RE: Engineer's Certification Plan for Lot 141, Unit 2, Sandia Heights South (C23/D58) (PWDN-990008) Submitted for Certificate of Occupancy Approval, Engineer's Certification Stamp Dated 2/10/00.

Lot 141 - Kelly Residence Sandia Heights South, Unit 2

Drainage and C-1Grading Plan Sh. 1 of 1

AREAS OF MODIFICATION BETWEEN APPROVED DRAINAGE GRADING PLAN AND ACTUAL AS-BUILT

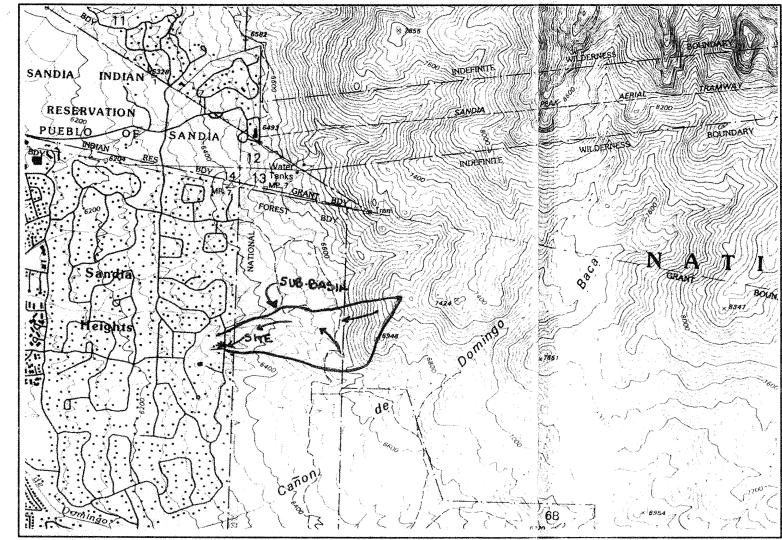
Location of area drain inlet revised. See separate as-built photos. OKAY. Storm drain outlet location revised to comply with Environmental Health Setback requirements. OKAY.

FF elevations revised 0.7' to 3,8' higher than design elevations. OKAY. Additional Cobble erosion protection installed along east and south side of building. See separate as-built photos. OKAY.
